Technical Service Bulletin: TSB200114

New Gear Cover Spacer Plate Gasket

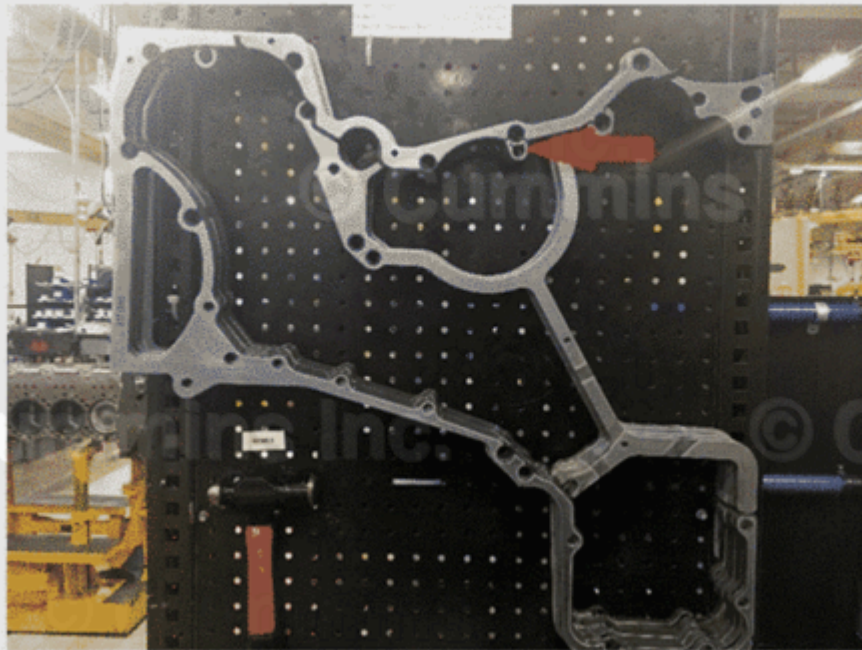
New gasket is more robust against oil leaks and provides common gasket between K19 and QSK19 engines.

Increased gasket retainer height prevents rubber bead from tearing while maintaining sealing pressure.

00r00447

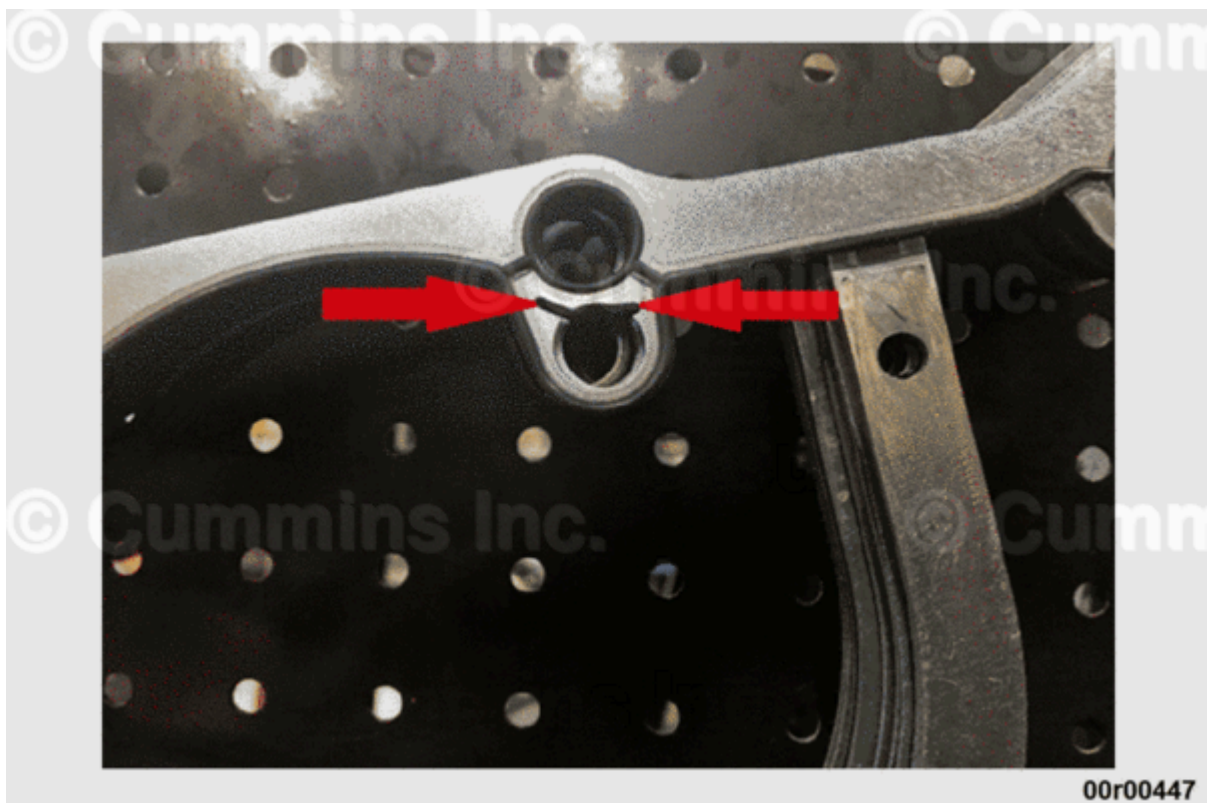
- Tab **must** be removed by cutting along pre-scored marks. See Figure 2 below.
